Docket Number:
02-REN-1038

**Pilot Performance-Based Incentive Program for the Emerging Renewables Program
and other changes to the Emerging Renewables Program Guidebook**

Comments on Pilot Performance-Based Incentive Program for the Emerging Renewables Program and other changes to the Emerging Renewables Program Guidebook

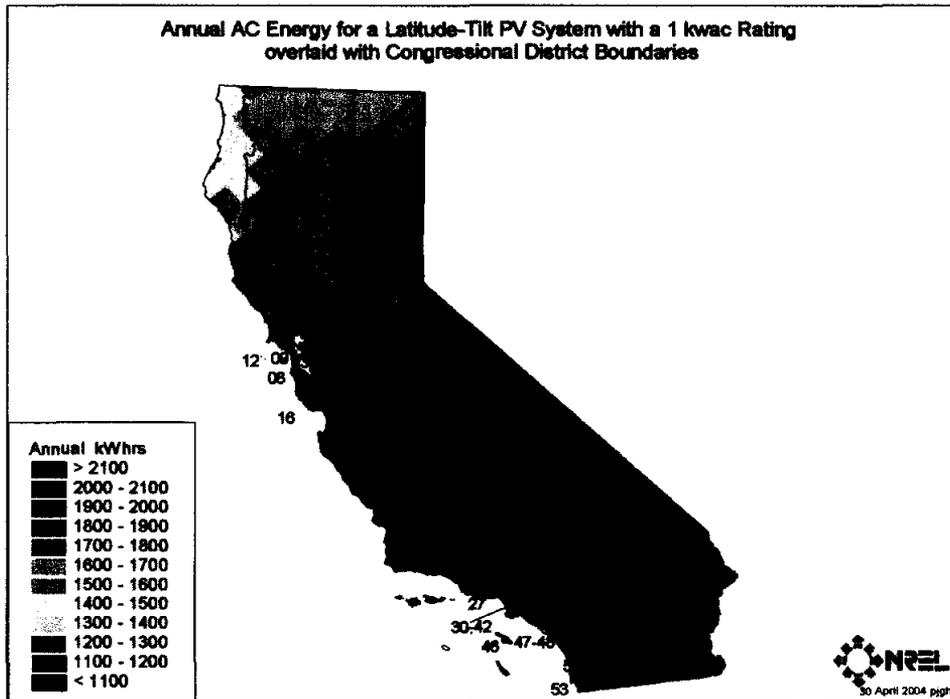
Golden Sierra Power Inc. recommends Energy Commission follow the proposed System Design based on the following information. This system design is currently being used by Venezio's Winery, which is producing kWAC nameplate rating numbers unlike all other systems in the State of California. This system design was recently supported by

the California Energy Commission's Energy Efficiency Financing Program with a Pre-Approved Loan Amount based on the kWh production of this Design Model. (A copy of the pre approval email and amortization schedule).
